ADDENDUM NO: 3

PROJECT: BCSC Columbus East High School – C4 Addition

PROJECT NO: 2025022 DATE: 11/10/2025 BY: Josh Cannaday

DRAWING NUMBER
C100

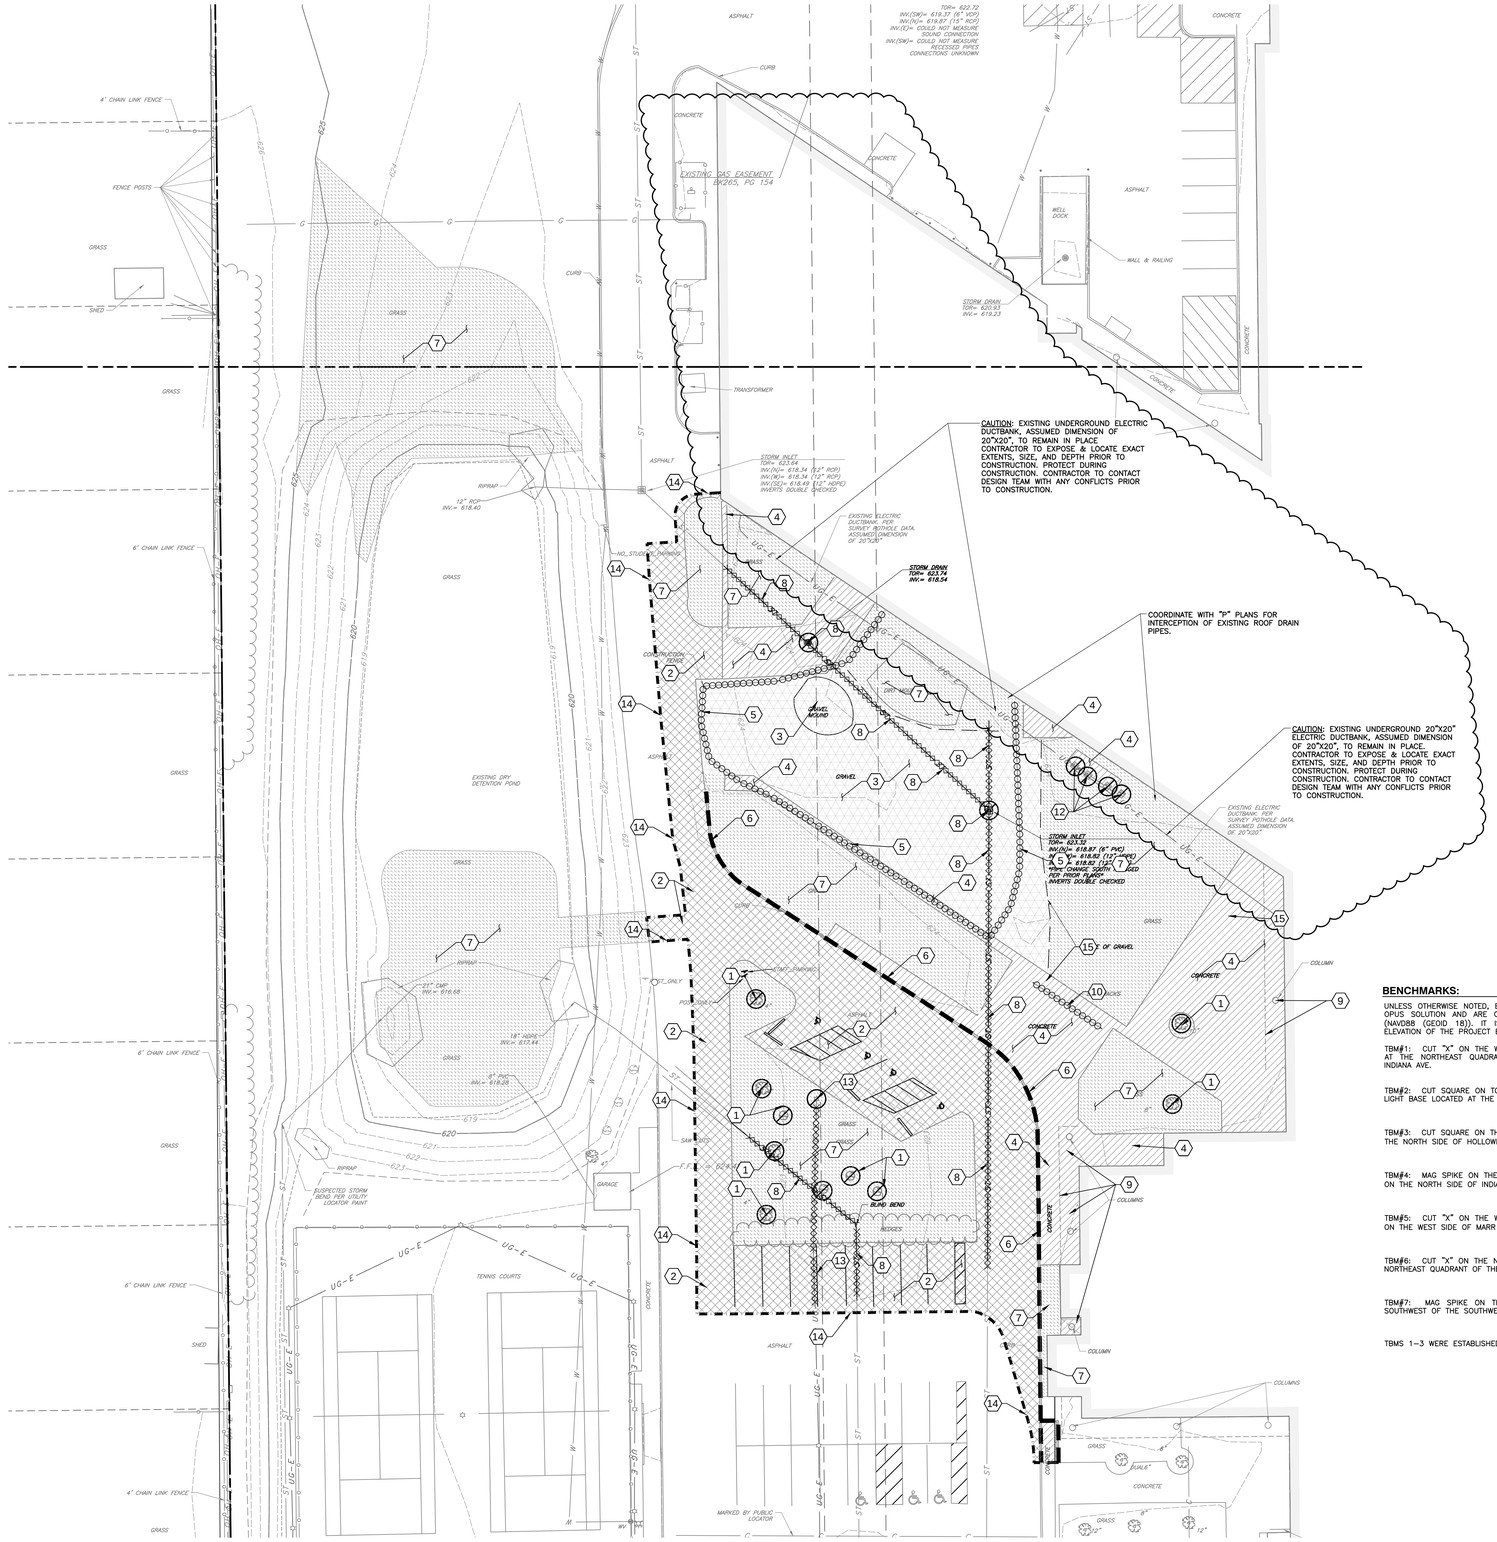
3.2 SHEET C100 – DEMOLITION PLAN

A. Modified cautionary notes for the existing underground electric duct bank

DRAWING NUMBER
C500

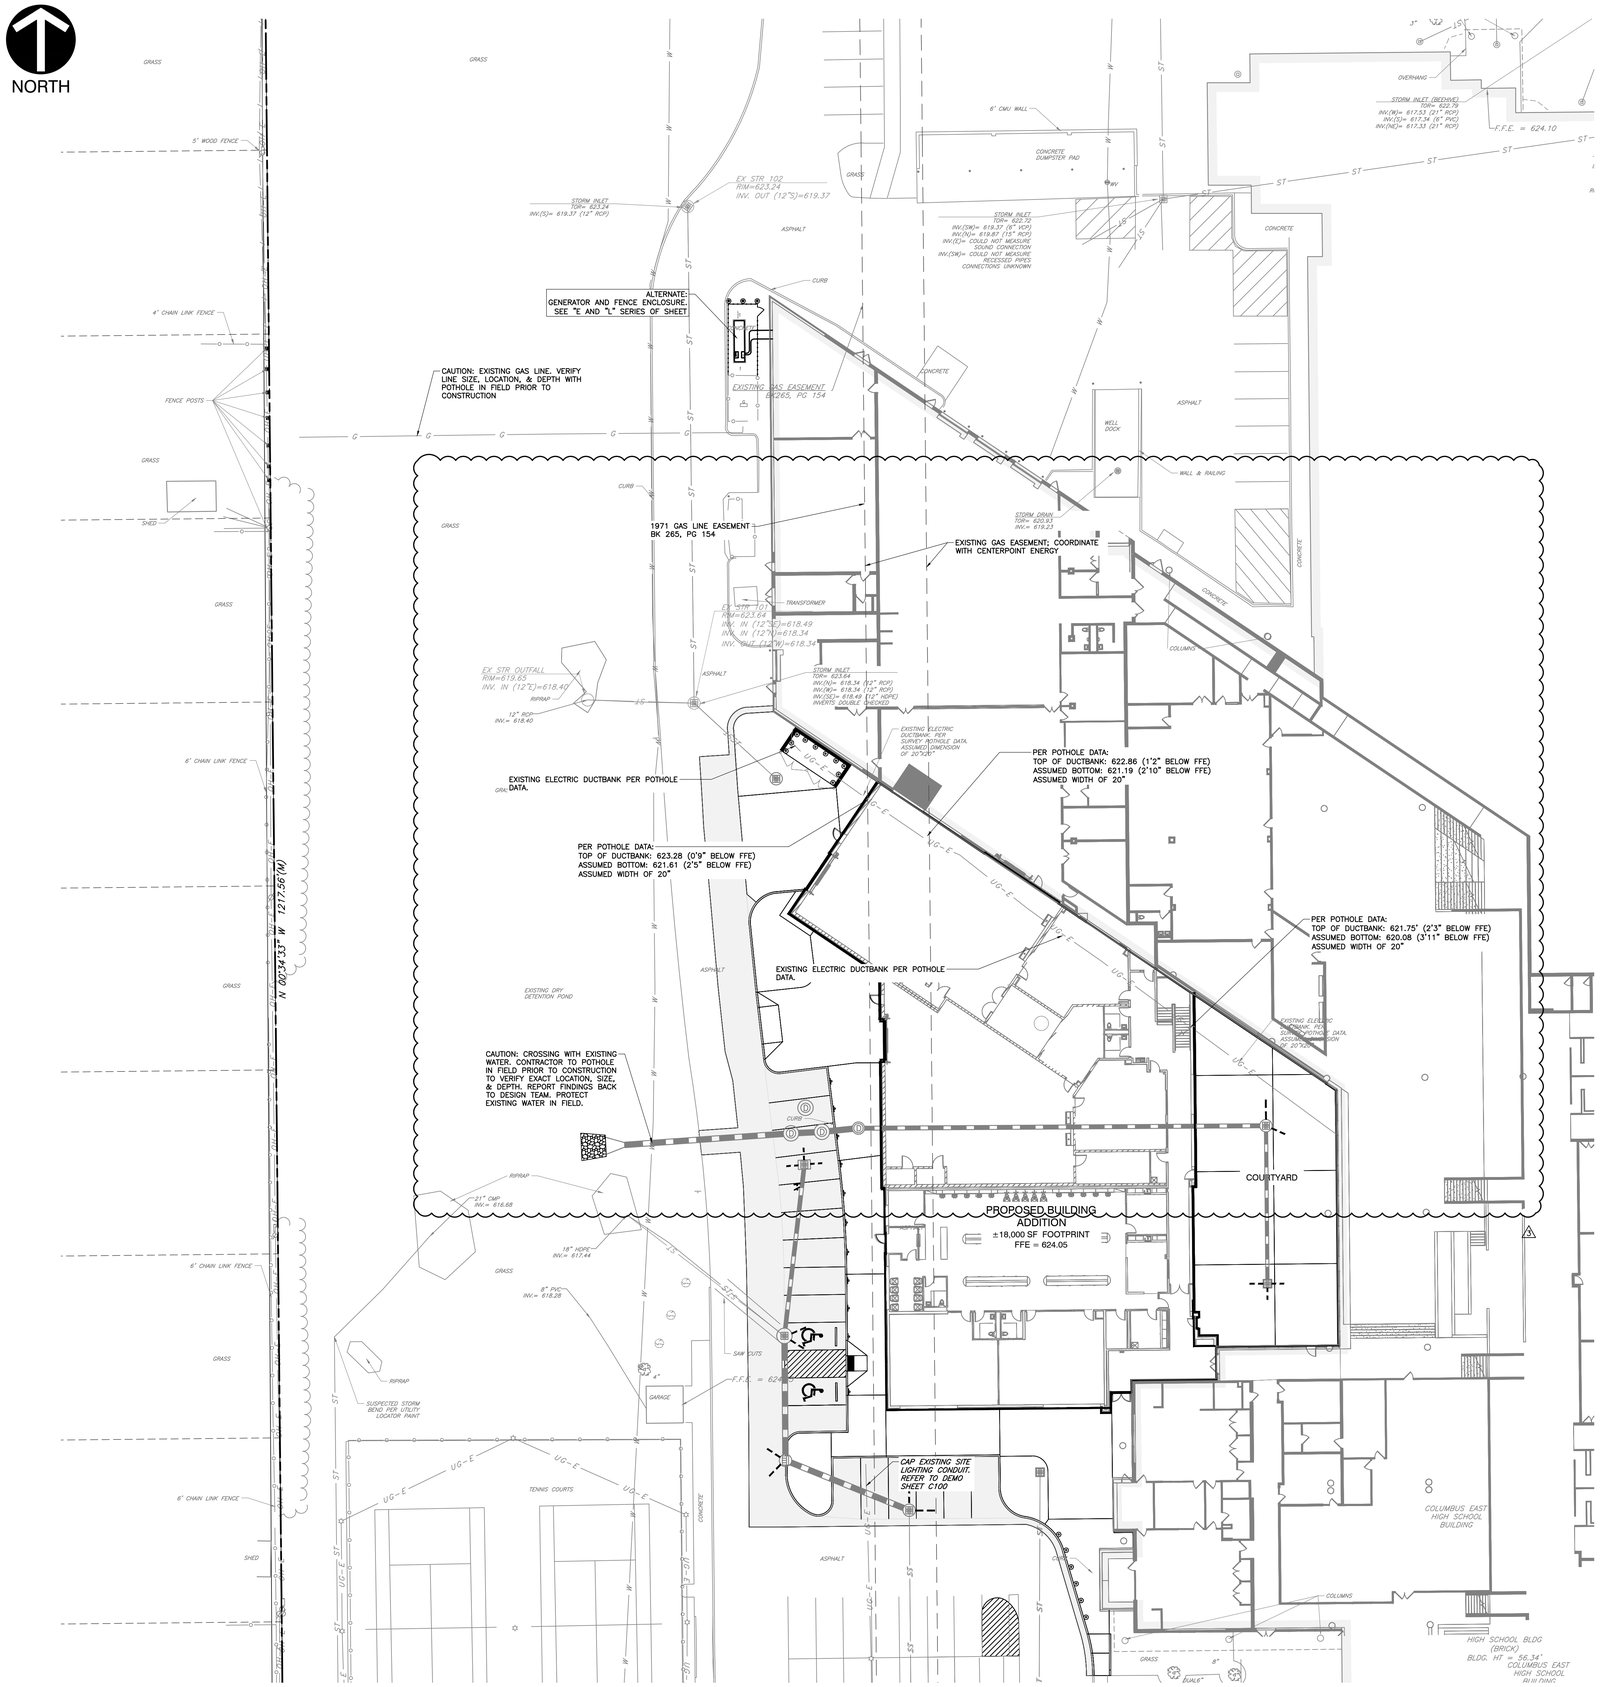
3.3 SHEET C500 – UTILITY PLAN

A. Added notes to reflect pothole data for existing electric duct bank

B. Added assumed elevations and depths of electric duct bank per pothole data

C. Added a cautionary note for utility crossing along the existing detention's eastern edge

D. Added easement identification notes

DRAWING TITLE:
SITE PLANTING PLAN

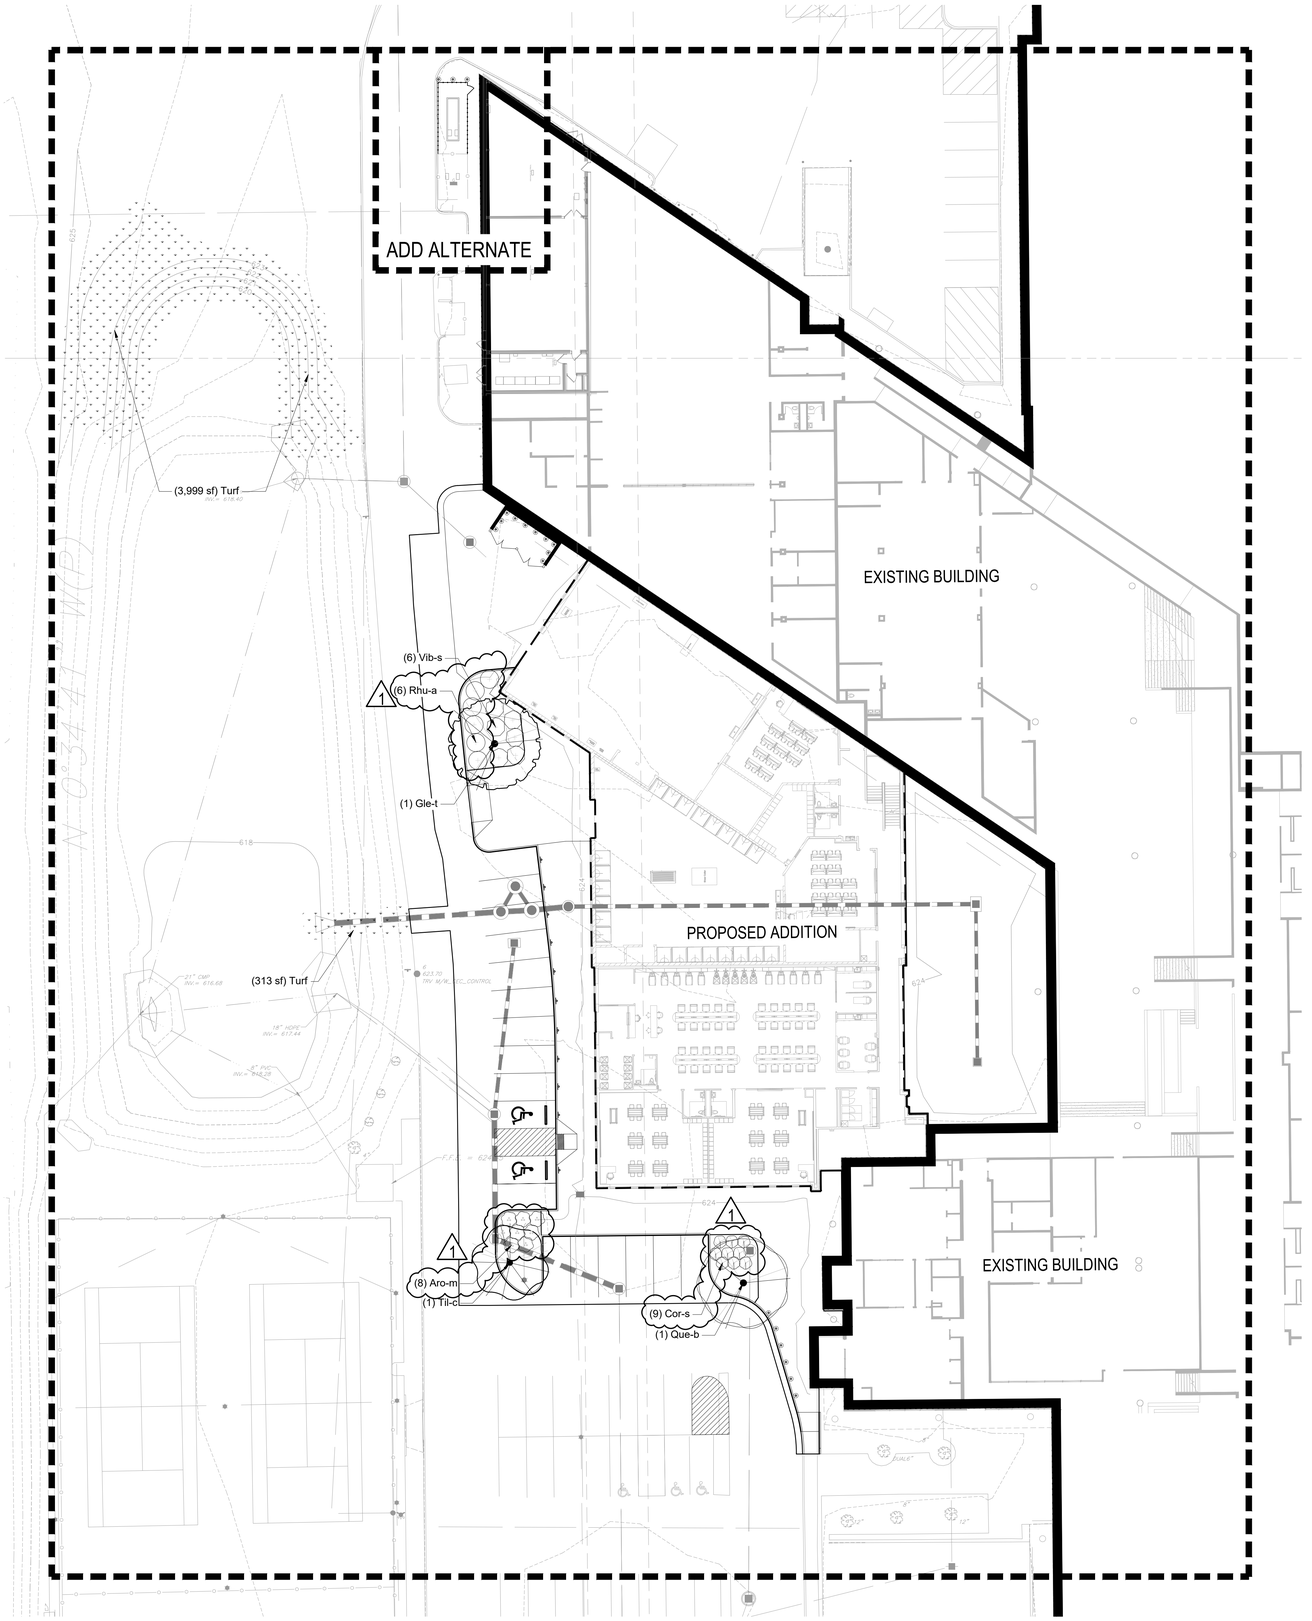
3.4 SHEET L401 – SITE PLANTING PLAN

A. Adjustments have been made to the required plants based on comments from the City of Columbus

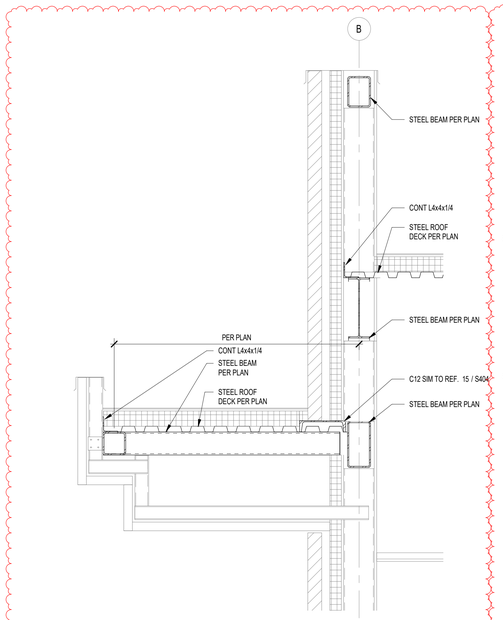
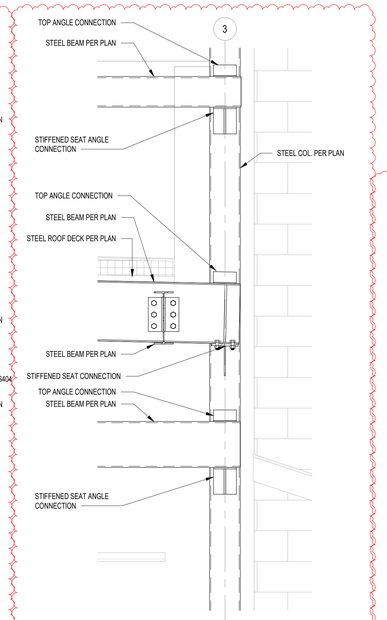
3.14 SHEET S703 – FRAMING SECTIONS & DETAILS

A. Sections 7-10/S703 added to detail list.

1 A201 FIRST FLOOR PLAN
SCALE: 1/8" = 1'-0"

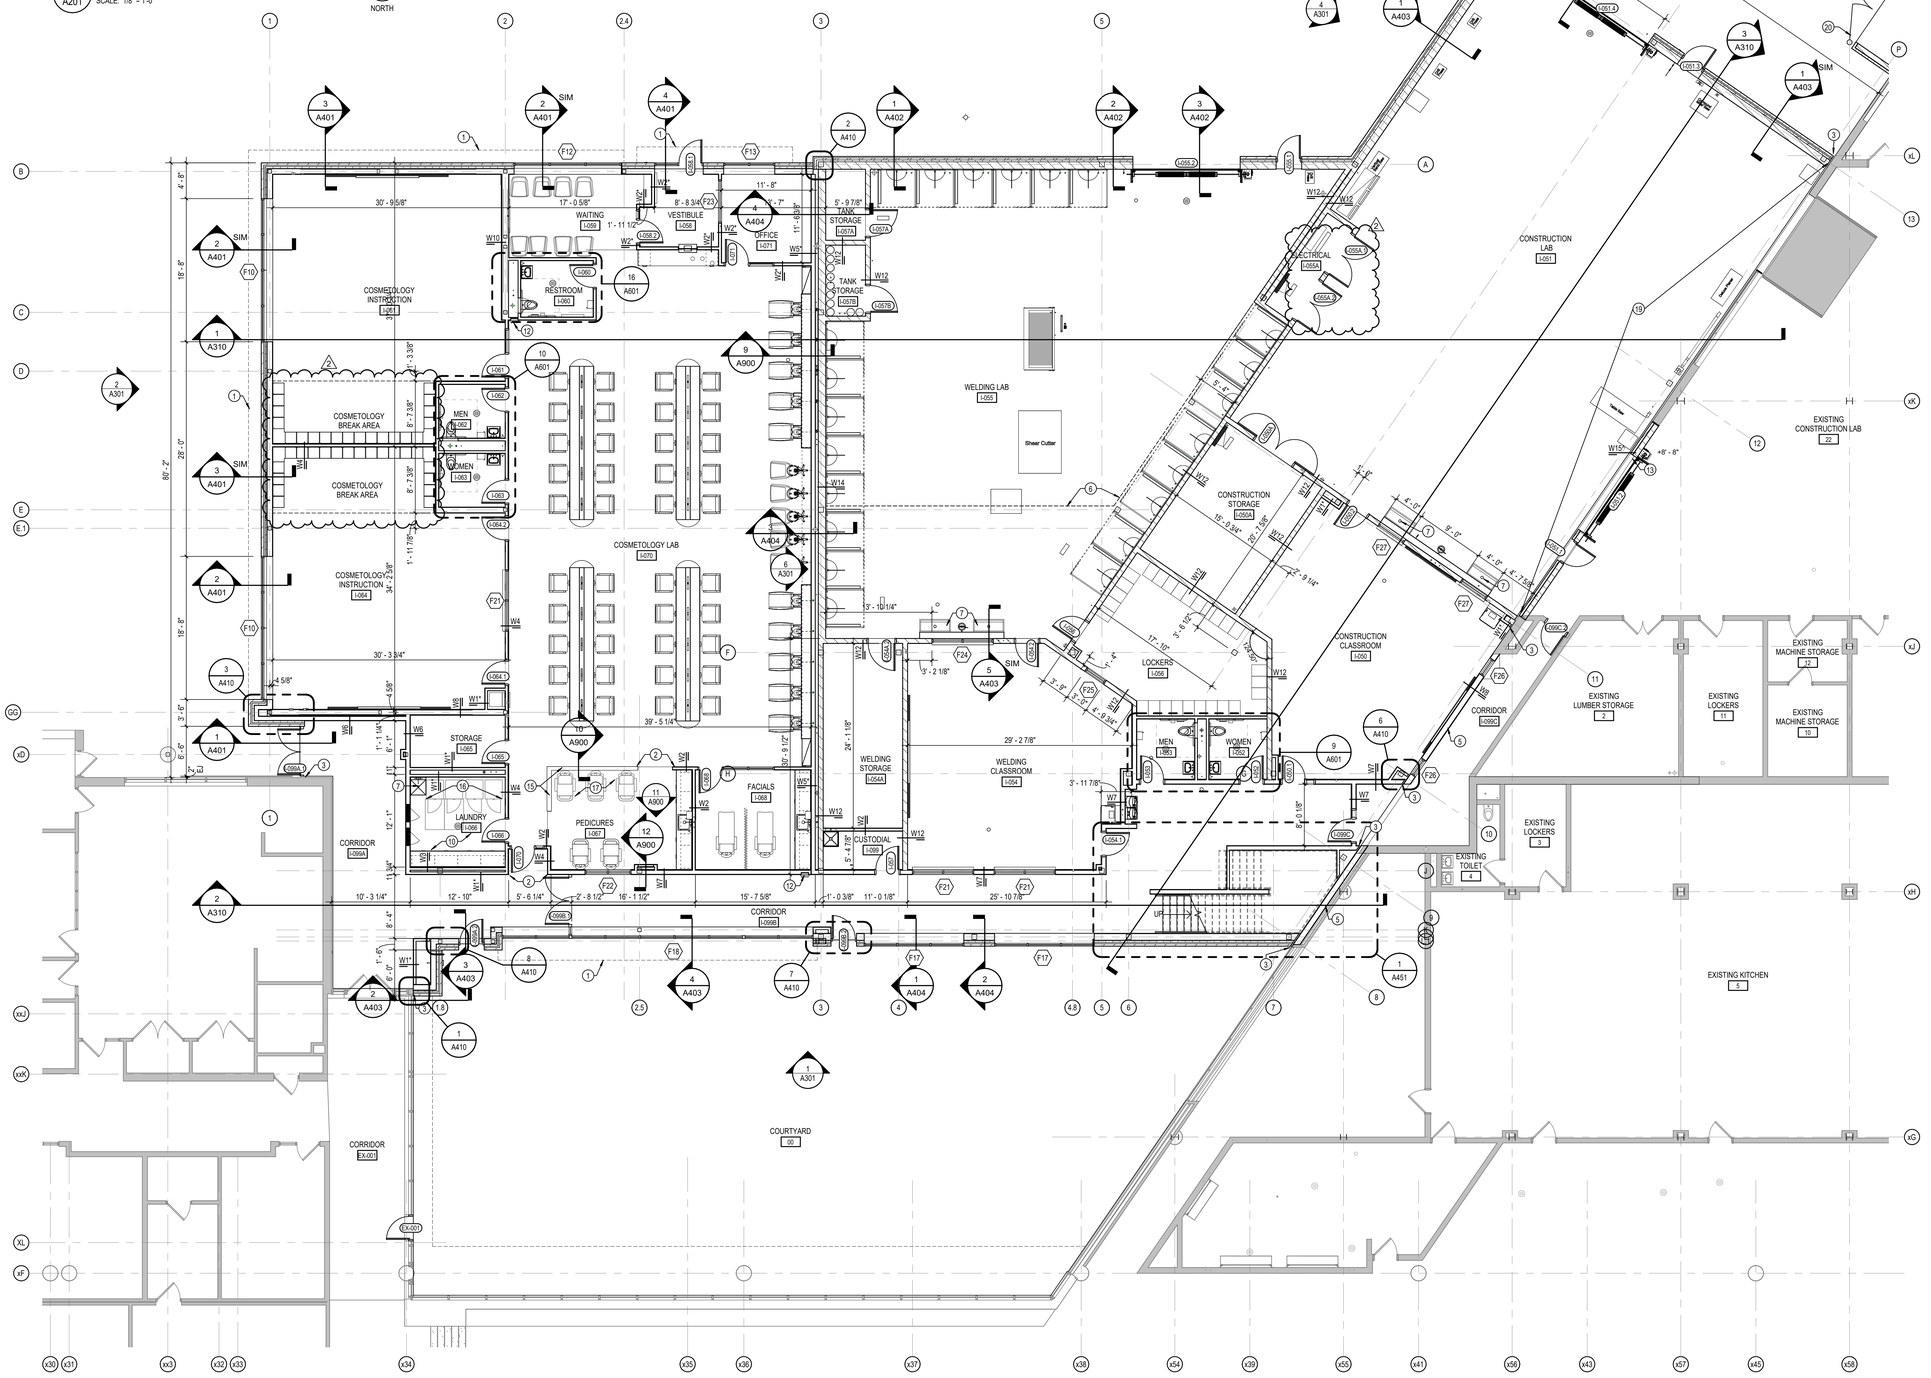
3.15 SHEET A201 – FIRST FLOOR PLAN

A. Add delineation line and tag for "COSMETOLOGY BREAK AREA" to floor plan

B. Add section cut 12/A900

4 A401 WALL SECTION
SCALE: 3/4" = 1'-0"

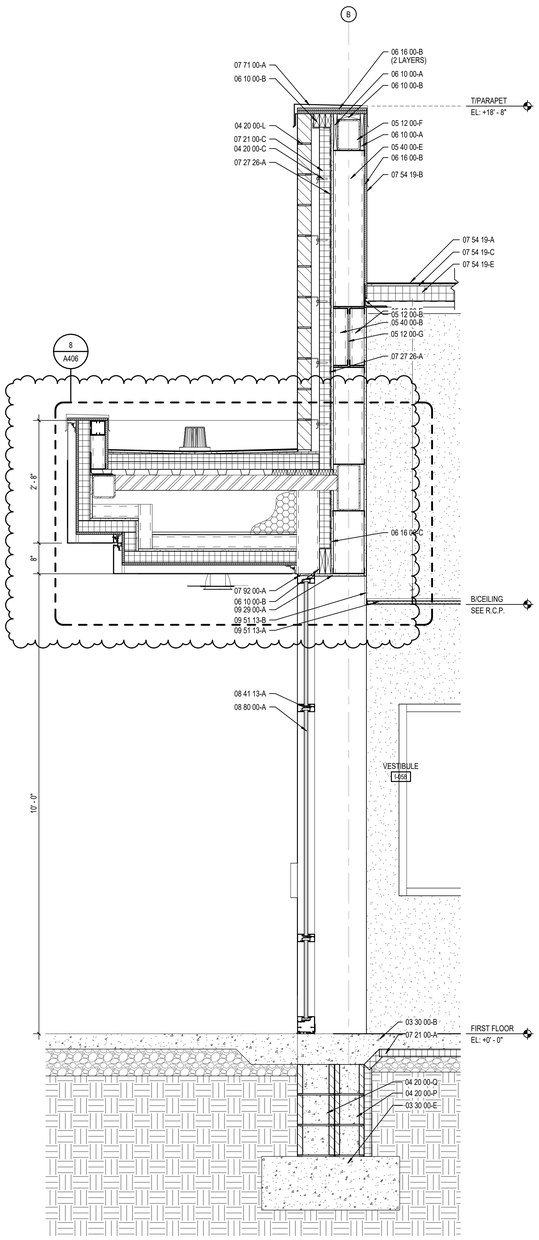
3.16 SHEET A401 – WALL SECTIONS

A. Add detail to canopy on section 4/A401
